**SUBMITTAL OF PLANS FOR CAPPING THE REMAINDER OF VAULT ONE,
Z-AREA SALTSTONE FACILITY (IWP-217) (U)**

Design Change Package (U)

DCP No. C-DCP-Z-93001	Classification <input checked="" type="checkbox"/> U <input type="checkbox"/> UCNI <input type="checkbox"/> Other	Rev. 7
------------------------------	---	---------------

Revision 7 of this DCP is issued in response to C-DCF-Z-00005, which requests several modifications to the existing cap design for Saltstone Vault No. 1. A partial disposition of C-DCF-Z-00005 was provided in revisions 4, 5 and 6 of this DCP. For design modifications to complete the capping of cells B through F, see pages 2 through 9 of this DCP.

SALTSTONE VAULT #1 ISOMETRIC

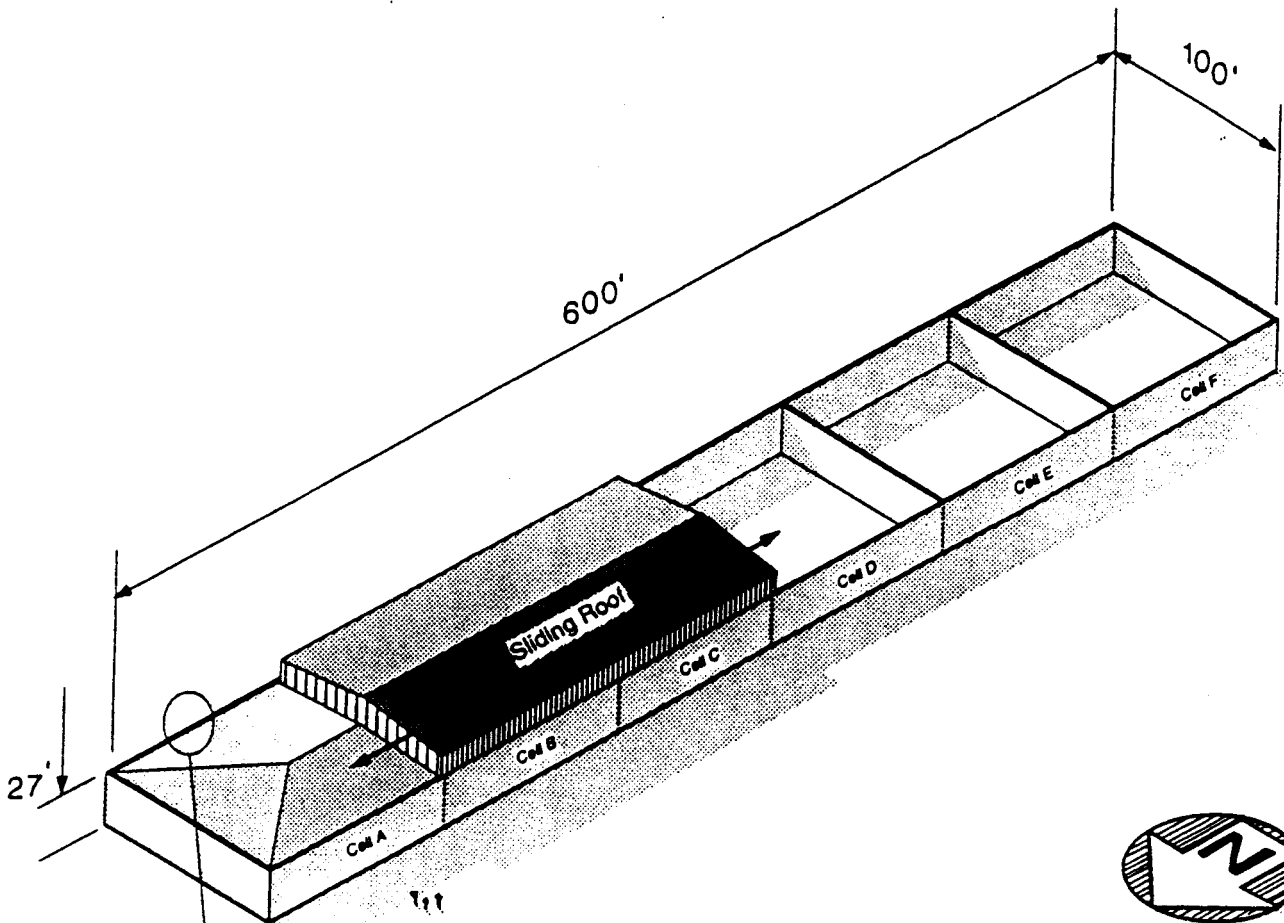
See Detail 1 for an enlargement of this area.

Since the original design for capping cell A of Saltstone Vault No. 1, as shown on drawing C-CC-Z-0010, has been changed due to lessons learned during the construction phase of cell A, the remaining cells (B through F) need a new design.

The capping of Cells B through F shall be completed in accordance with Drawing No. C-CC-Z-0010, sketches on pages 2 through 4 of this DCP, and with the requirements listed below.

DETAIL

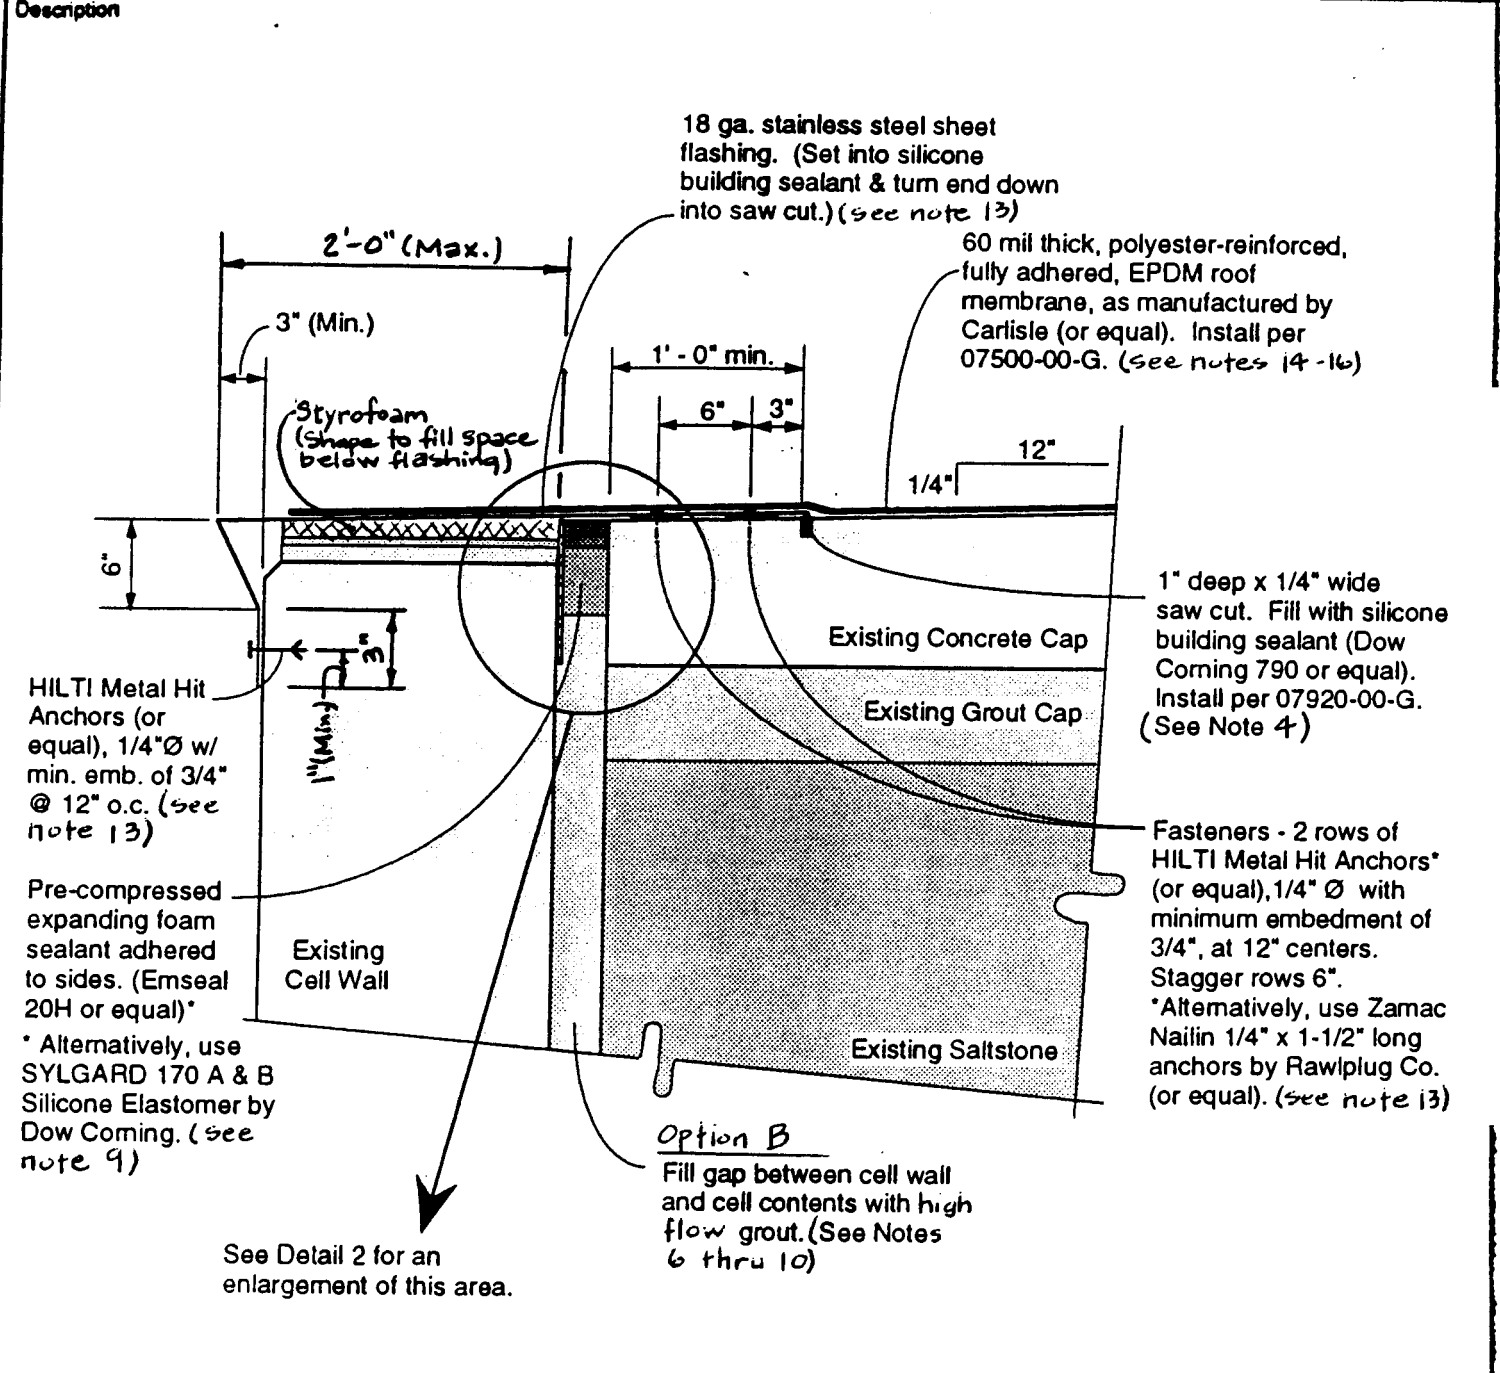
There are two options provided. **Option A assumes there is essentially no gap between the vault wall and the interior grout/concrete layers. Option B assumes that there is a gap.** (Note: If Option A or Option B are not shown with a note, then the note applies to both options).

1. The 6" (min.) "Clean Grout" layer shall be poured prior to removing the temporary/movable roof. This clean grout layer (or personal protection layer) shall be as level as possible, prior to pouring the 6" (min.) reinforced concrete layer, by pouring through the existing 4 portholes at the four quadrants of the existing movable roof at an equal rate and volume and through the center porthole, in order to provide a level surface. The grout to be used shall be high flow grout, type A2000-X-0-0-AB, in accordance with C-SPS-G-00041.

3. Place the 6" reinforced concrete layer in accordance with Drawing No. C-CC-Z-0010. **Option A:** Place a 2" x 5-1/2" expansion joint strip and a 2" wide x 1/2" deep (max.) filler strip (on top), wrapped in a plastic bond-breaker sheet, at the edge of this layer. These 2" wide strips shall be placed flush with the inside face of the cell wall and up to the top of the existing vertical embedded plate.
